SUNDRY NOTICES AND REPORTS ON WELLS

Bootleg 24 Federal #1

OXY USA WTP LP - Proposed
Bootleg 24 Federal #1
API No. 30-025-35512

Temporary Abandonment of Wells on Federal Lands
Conditions of Approval

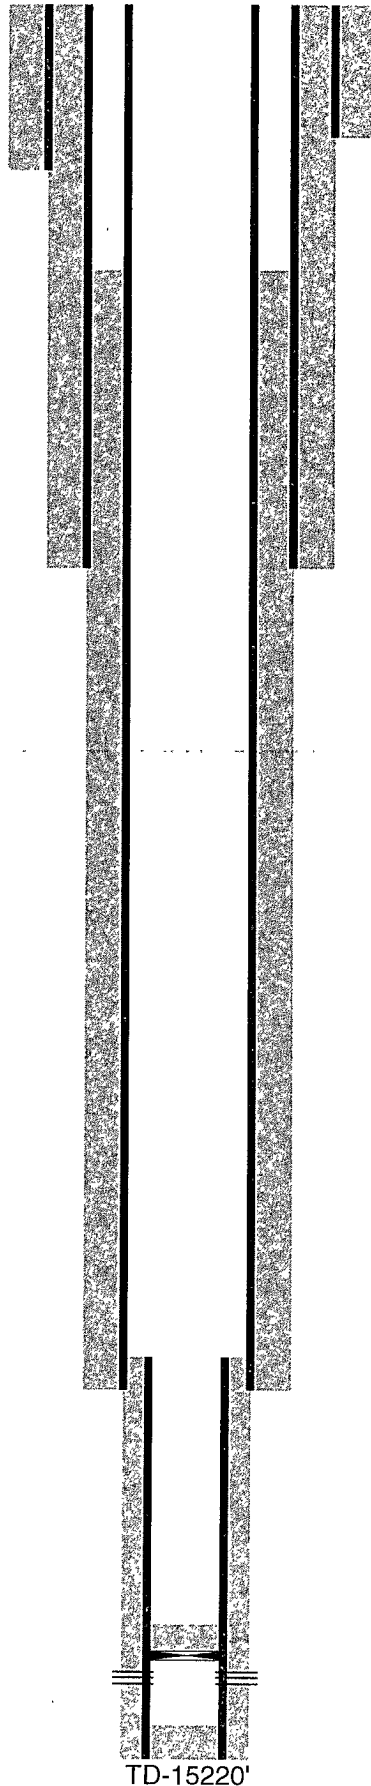
Bootleg 24 Federal Well #1. Well may be approved to be TA/SI for a period of 6 months after successful MIT and subsequent report with well bore diagram is submitted. This will be the last and only TA/SI approval. Well must be P&A or plans to return to beneficial use submitted by October 1, 2010.

1. **Submits a subsequent Sundry Notice** (Form 3160-5) requesting TA approval **with well bore diagram** with all perforations and CIBP's and tops of cement on CIBP's.
2. Describes the temporary abandonment procedure.
3. Attaches a clear copy or the original of the pressure test chart.
4. Give justification to allow well to be place in TA status and plan for future use of well with time frame that well will be place back on line or plans to P&A well will be submitted.
